Project	IEEE 802.16 Broadband Wireless Access Working Group < http://ieee802.org/16 >
Title	Enhanced HARQ technique using Constellation Rearrangement
Date	2007-11-07
Submitted	
Source(s)	Jer-Chung Lin, Ren-Jr Chen, Chung-Lien Ho, Voice: Chang-Lan Tsai, Chang-Lung Hsiao, Chi-Fang E-mail: whsheen@itri.org.tw (Richard) Li, Ting-Chen (Tom) Song, Yu-Chuan richard929@itri.org.tw Fang, ITRI Wern-Ho Sheen, NCTU/ITRI
Re:	IEEE 802.16m-07/040 - Responds to Call for Contributions on Project 802.16m System Description Document (SDD)
Abstract	New HARQ method using signal constellation rearrangement is presented in this contribution, where different mappings are used for retransmission to improve performance. It is proposed to adopt the technique in the IEEE 802.16m SDD HARQ section for further investigation.
Purpose	For 802.16m discussion and adoption
Notice	<i>This document does not represent the agreed views of the IEEE 802.16 Working Group or any of its subgroups. It represents only the views of the participants listed in the "Source(s)" field above. It is offered as a basis for discussion. It is not binding on the contributor(s), who reserve(s) the right to add, amend or withdraw material co

Figure 2.1.1~2.1.4 Constellation rearrangement for 16 QAM (bars indicating rows/columns for which the respective bit equals 1)

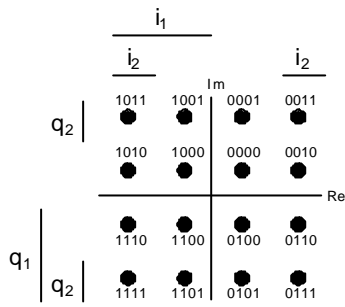
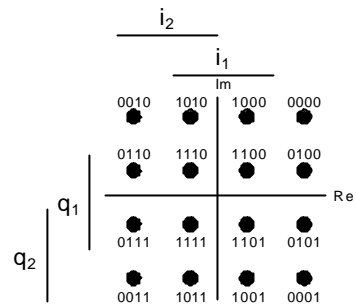
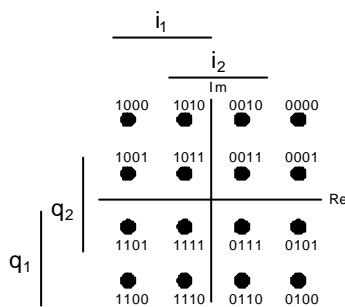
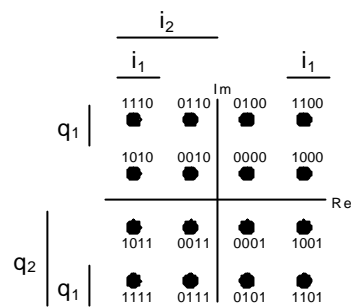
For Gray labeling in 16QAM as shown in Figure 2.1.1, bit i_1 is more reliable than i_2 . If the same labeling is retransmitted for repeated bits, the reliability of bit i_1 will be further higher than i_2 . To resolve the un-even bit reliabilities, we swap bit i_1 with bit i_2 and obtain different mapping for retransmission. Similar argument applies to q_1 and q_2

An HARQ method with signal constellation rearrangement for 16-QAM and 64-QAM modulation shall be used.

Figure 2.2.1~2.2.6 Constellation rearrangement for 64 QAM (bars indicating rows/columns for which the respective bit equals 1)

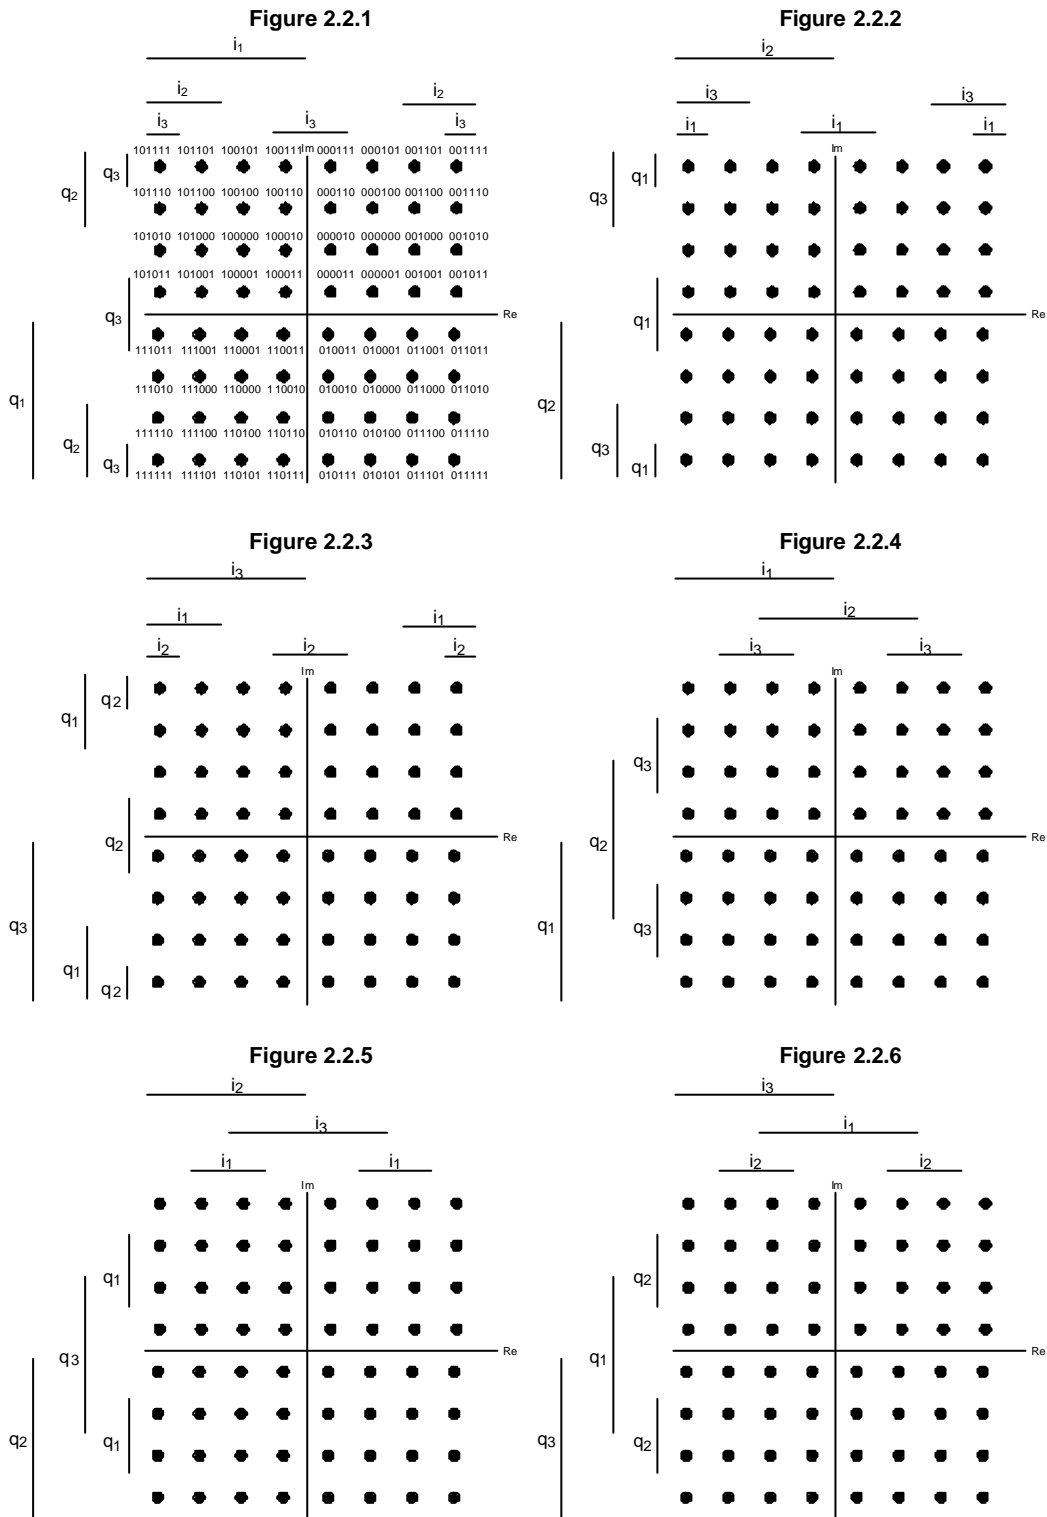
For Gray labeling in 64QAM, there are three different reliabilities levels as shown in Figure 2.2.1. The reliability levels from high to low are i_1 , i_2 , and i_3 respectively.

Similar to the approach for 16 QAM, we swap bits with different bit reliability levels to obtain better performance.
